Service Bulletin

26-034

Eaton Endurant / PACCAR AMT Fluid Pressure Sensor Clearance

Figure 1

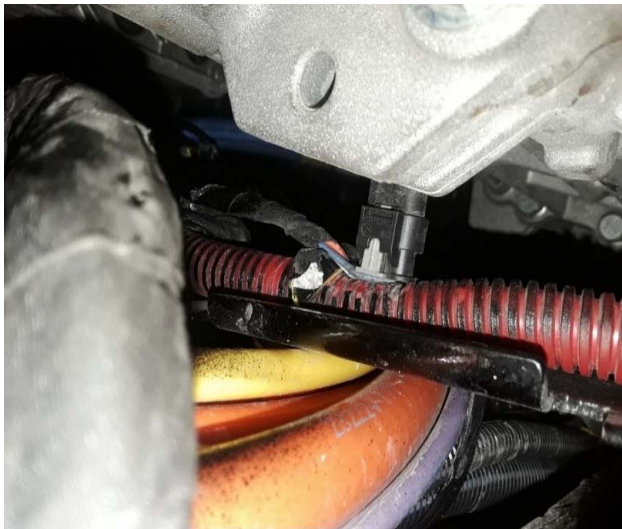
1. Inspect for clearance between the transmission fluid pressure sensor and the chassis bundle and surrounding routing brackets.
2. If a rub exists (example in Figure 1), disconnect the harness from the sensor.

3. Remove the transmission fluid pressure sensor.
4. Install the 90-degree fitting pointed toward the front of the truck and angle slightly downward (oriented between 8 o'clock and 9 o'clock), as shown in Figures 2 and [3](#). The downward angle is necessary to avoid water accumulation. Torque the fitting to 25-28 ft-lbs (34-38 Nm).
